SITE PLAN: P01 - P09
SCALE: 1:100

REAL ESTATE/EASEMENT		PERMIT		
					CITY OF PUYALLUP				
3					FUNCTION	CONTACT	PHONE NO	DATE	
2					PROJECT MGR	J. REYNA	253-259-7076	08/13/21	
1					ENGR - POWER	J. REYNA	253-259-7076	08/13/21	
REV#		DATE		BY	DESCRIPTION				
COUNTRY		Emer Sect	Gas Wk Ctr	POWER WK CTR					
PERCE		N/A	N/A	OWSPRE					
1/4 SEC		OP MAP		PLAT MAP		APPROVED BY			
T19N, R04E, 03S		N/A		N/A		2/16/24			
L-MAP NO (POWER)		OH CKT MAP		UG CKT MAP		FOREMAN #1			
1904E042, 037		1904E056		1904E042, 037		FOREMAN #2			
				SHA-16		MAPPING			
JOINT FACILITIES ARRANGEMENTS									
UTILITIES		N/A		N/A		N/A		N/A	
CONTACT		N/A		N/A		N/A		N/A	
PHONE		N/A		N/A		N/A		N/A	
 PUGET SOUND ENERGY				ENGR1 CLINK TK # 3870094				INCIDENT	MAOP
				REPLACE (6) POLES, UPGRADE GUYS & ANCHORS				Gas Order	Elect Order
				1106 39TH AVE SE., PUYALLUP, WA 98374				N/A	186054605
SCALE				AS NOTED				PAGE	2/2
DESIGNED BY POTELOCO

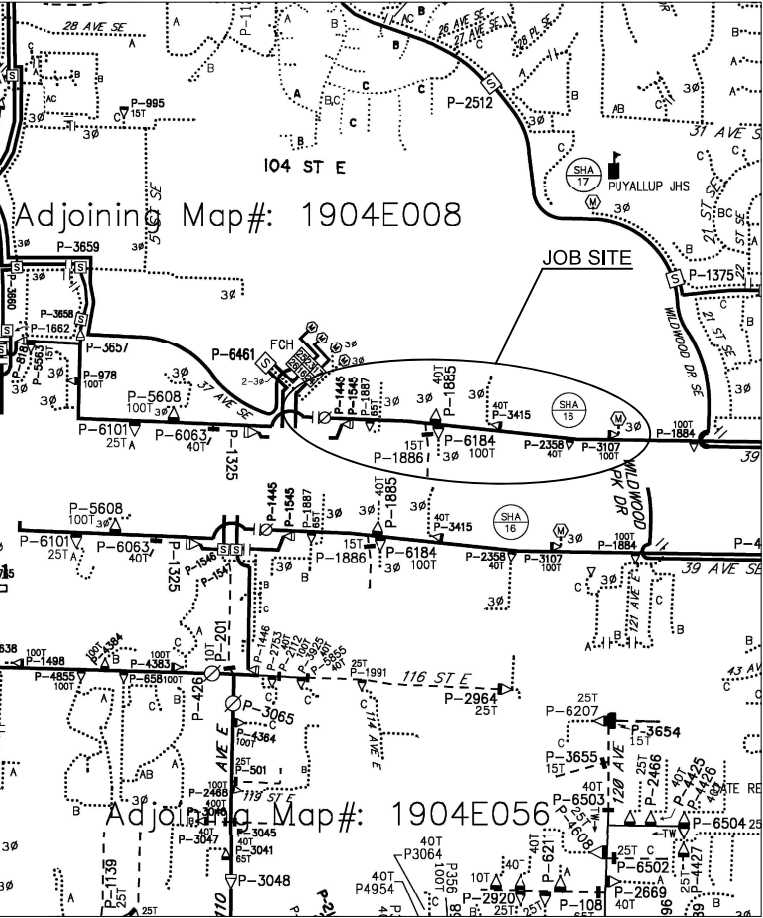
Site specific notes and other content on the site plan does not match the permit application for removing five poles. Redact any unrelated work from the site plan or update the project description on the application to match the proposed scope of work.
